RE: **STAFF SUMMARY REPORT (ADDENDUM)**
LARGE-SCALE DEVELOPMENT PLANS – HUDSON ROAD TOWNHOMES

PROJECT NAME:	Hudson Road Townhomes
ADDRESS/LOCATION:	1900 to 2044 W Hudson Road
PROPOSED USE:	Multifamily Residential
CURRENT ZONING:	C-3 (Neighborhood Commercial)
CGM GROWTH DESIGNATION:	Neighborhood Center
APPLICANT/REPRESENTATIVE:	Anderson Engineering, Inc. – Andres Forero
PROJECT OWNER/DEVELOPER:	Hudson Road Townhomes, LLC – Jeff S. Bay
PROPERTY OWNER:	Hudson Road Townhomes, LLC – Jeff S. Bay
NATURE OF REQUEST:	Approval of Large-Scale Development Plans
AUTHORITY:	Chapter 14, Article III, Rogers Code of Ordinances

Re: Conditional Approval of Civil Plans
Hudson Road Townhomes

UTILITY PLAN

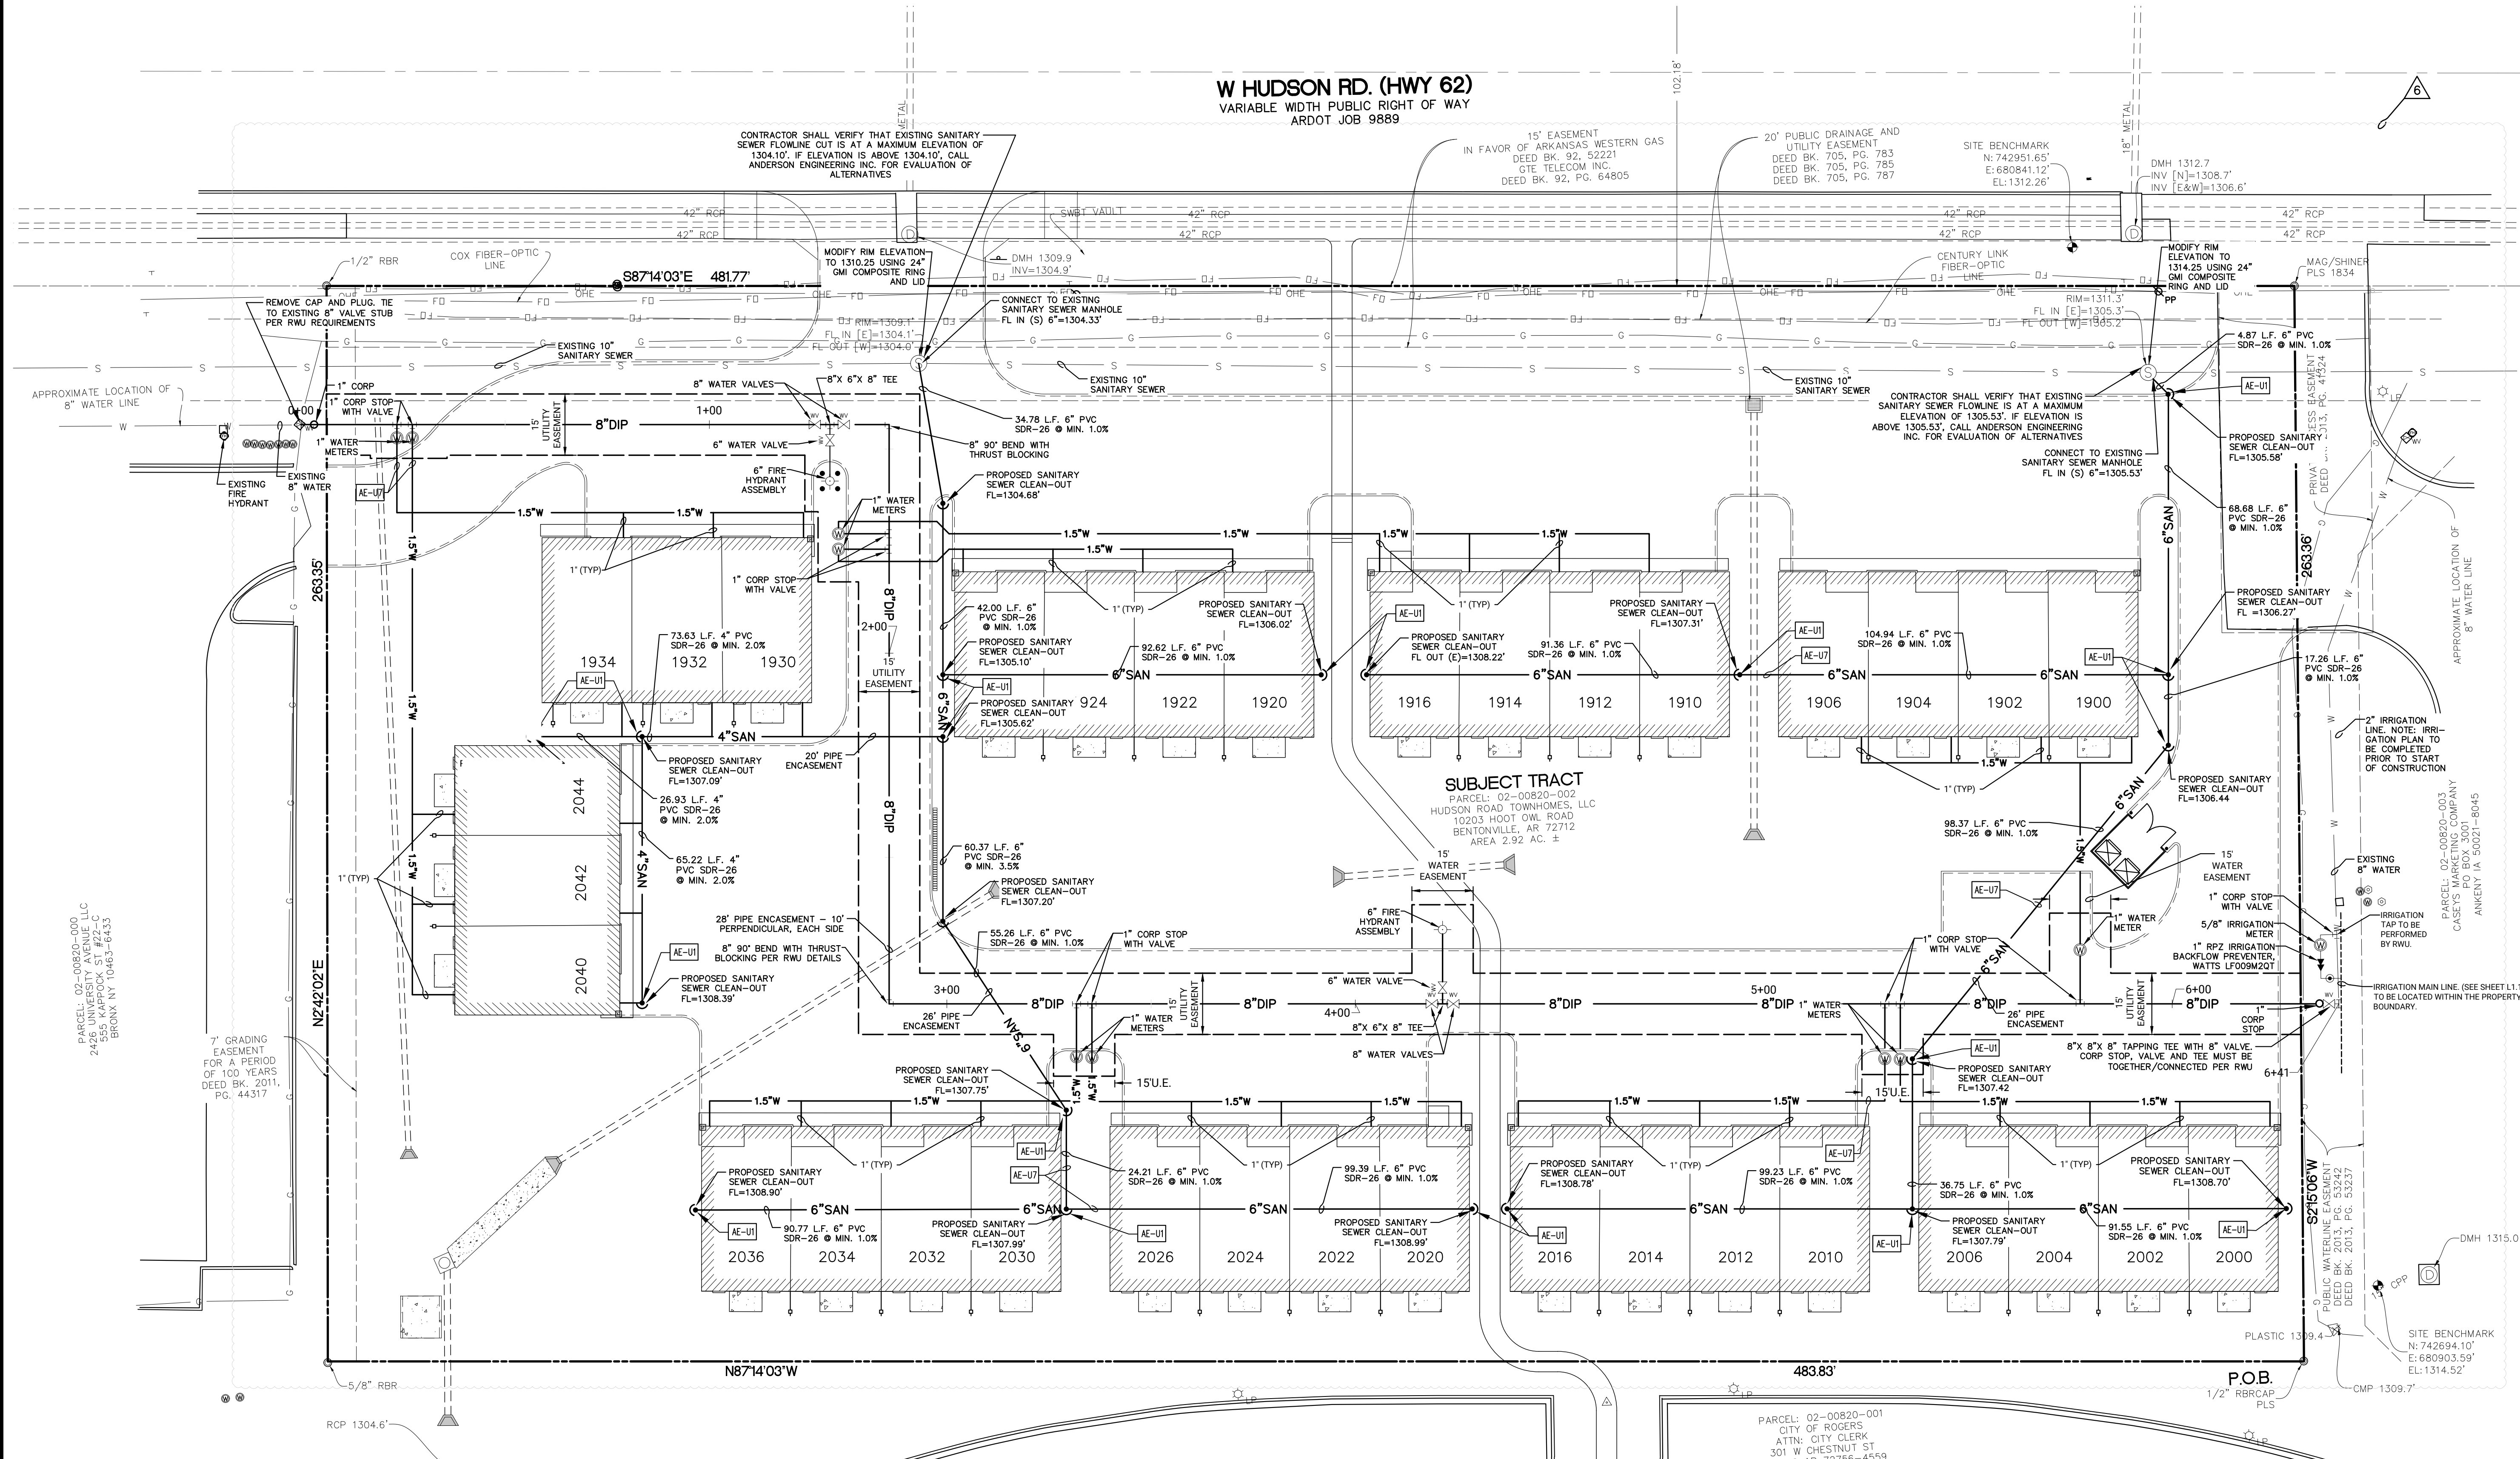
1. The water meter that serves Units 1900 to 1906 is not within a Utility Easement.
2. Show the encasement pipes centered on the sewer line on the Utility Plan.

3. Locate the proposed water main above the 6" Sanitary Sewer service where they cross near Sta. 5+47 of the proposed water main. It appears the water main will still have the required 3' of cover and can be 18" above the sewer at the crossing.

4. There appears to be a couple of "Southern Magnolias" less than 10' from water meters that serve the units along the south end of the site. There is also a "Maidenhair Tree" shown at the southeast corner of the site that will be too close to an existing water main in that area that is not shown on the plans.

HUDSON ROAD TOWNHOMES LLC
10203 HOOT OWL ROAD
BENTONVILLE, AR 72712
LANDSCAPE PLAN
HUDSON ROAD TOWNHOMES
HUDSON ROAD (HWY 62)
ROGERS, AR 72758

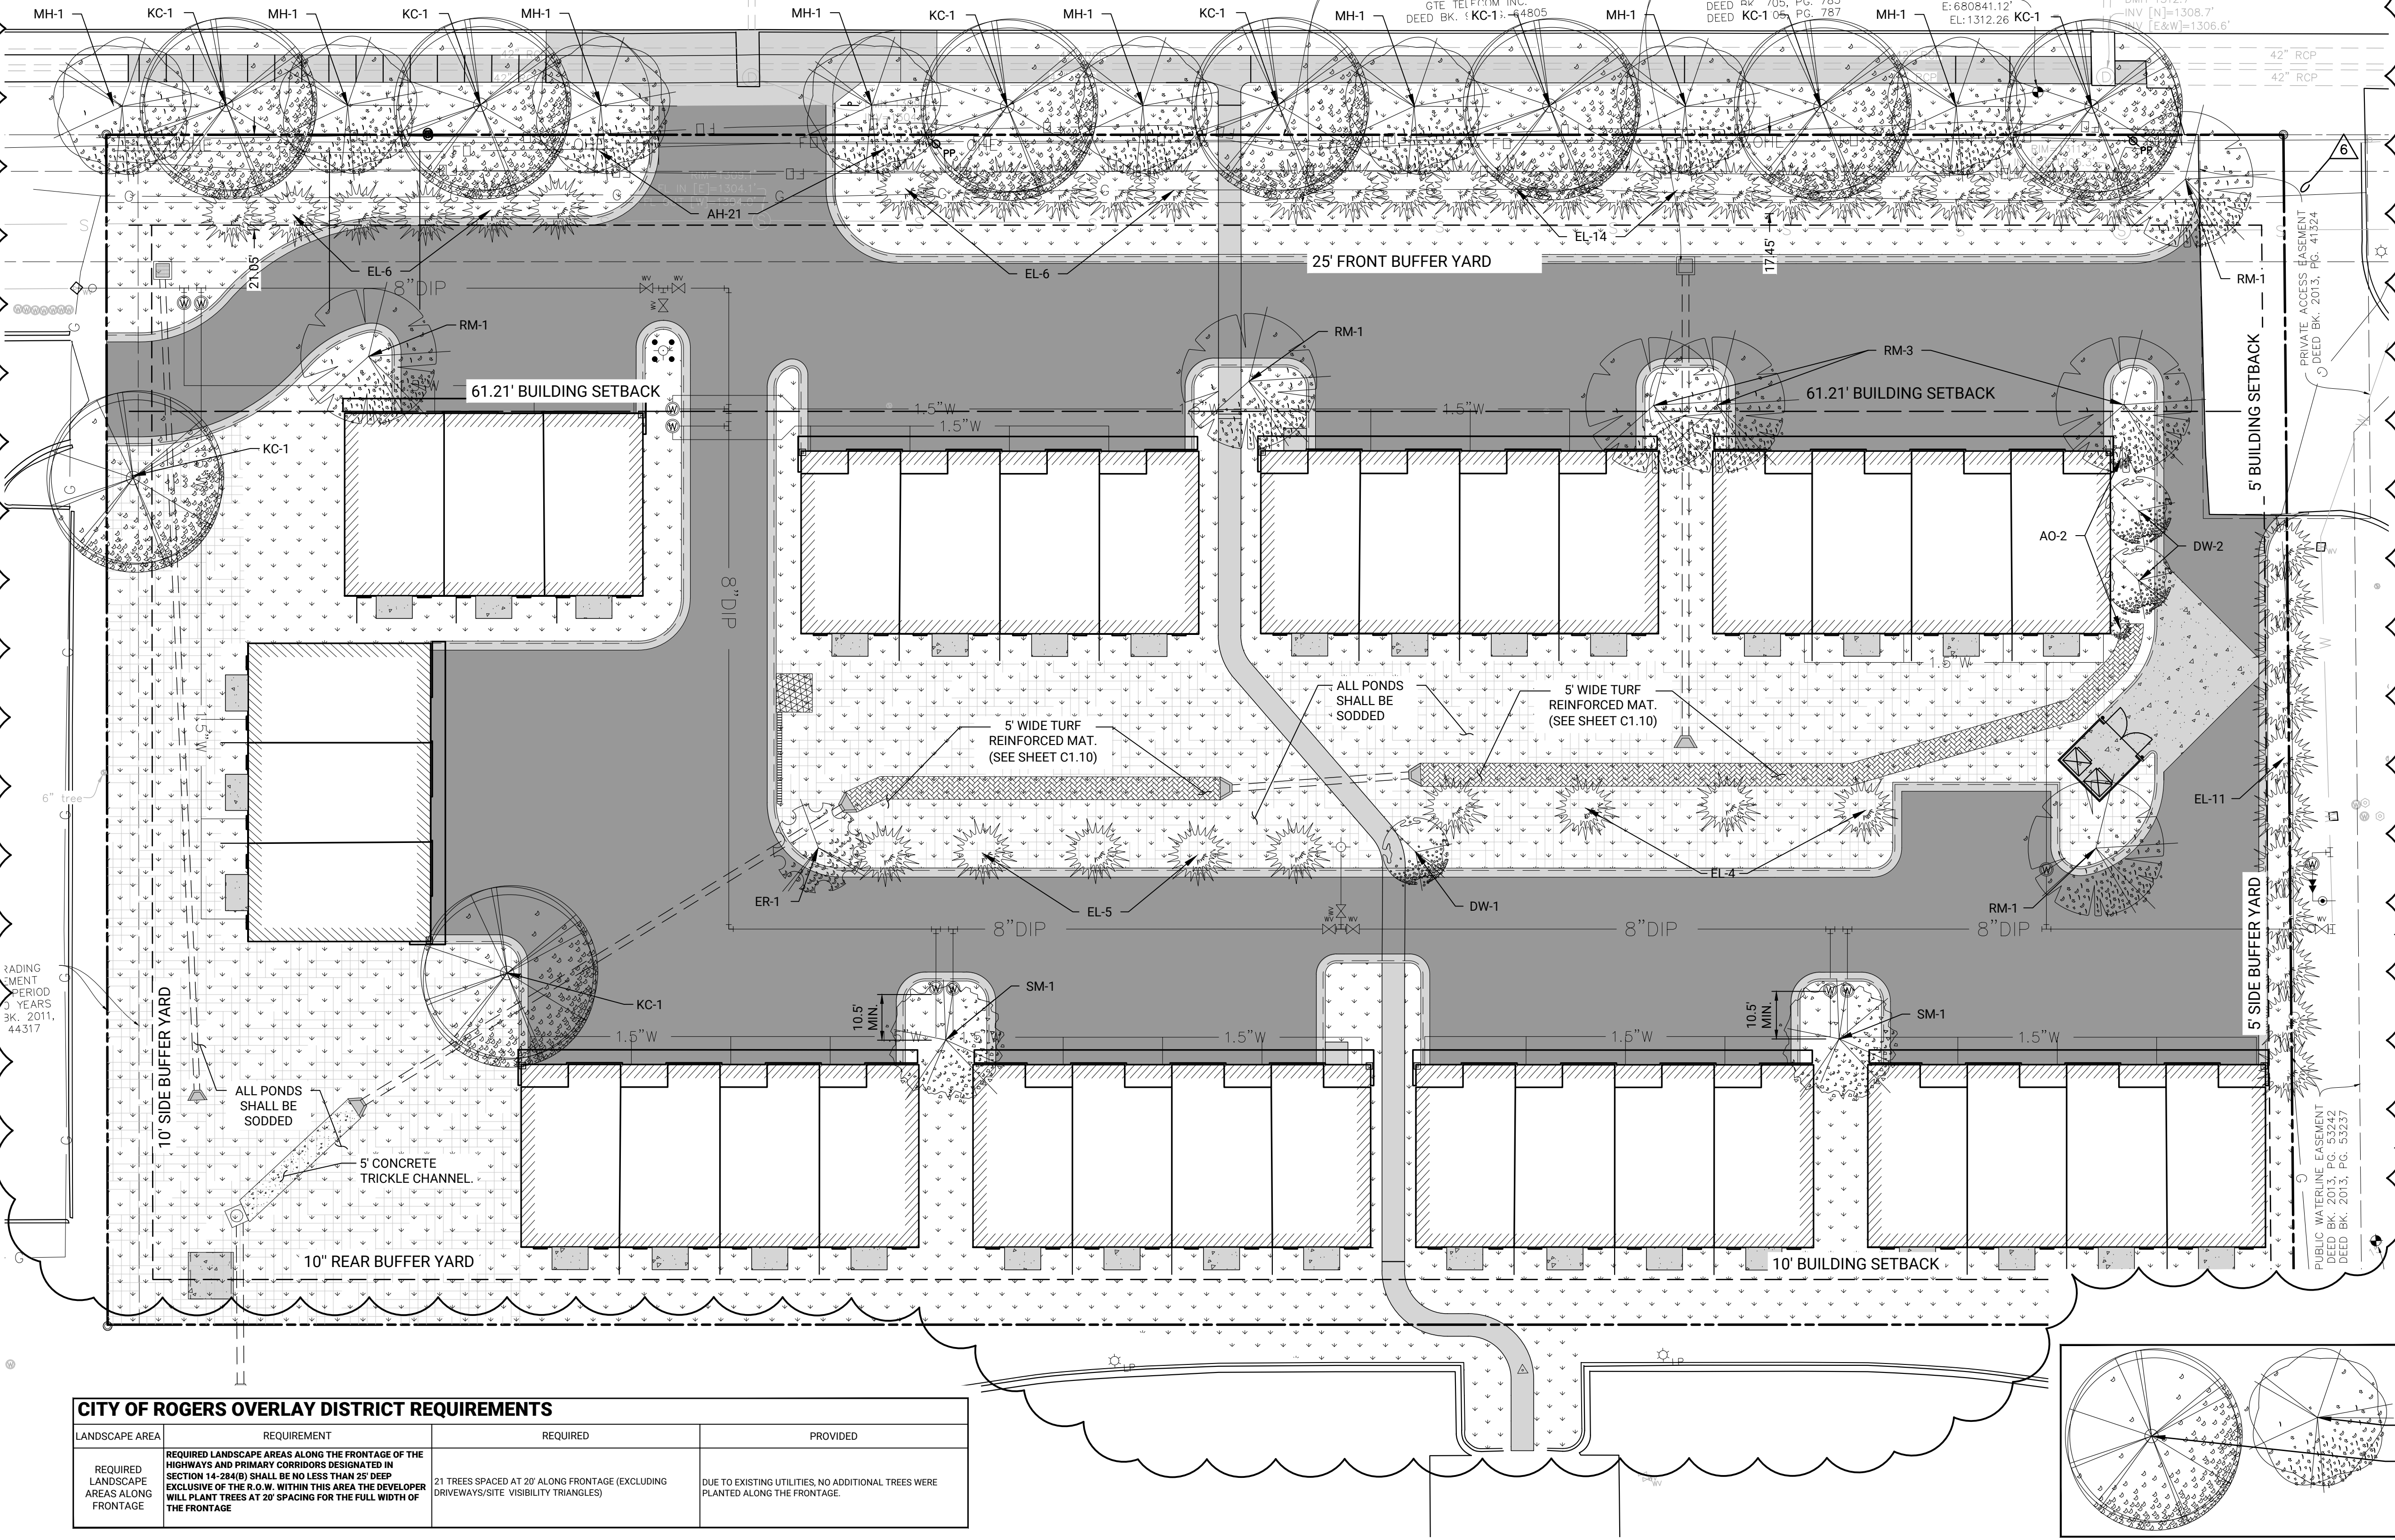
1. See full report for recommended actions on remaining waivers and variances.
2. In addition to the waivers and variances above, staff recommends that the proposed street trees to be native species from the Approved Street Tree list per recommendation from ArDOT. ArDOT indicated to Engineering Staff that consideration for Street Trees within ArDOT rights-of-way would be more effective if native species were selected.
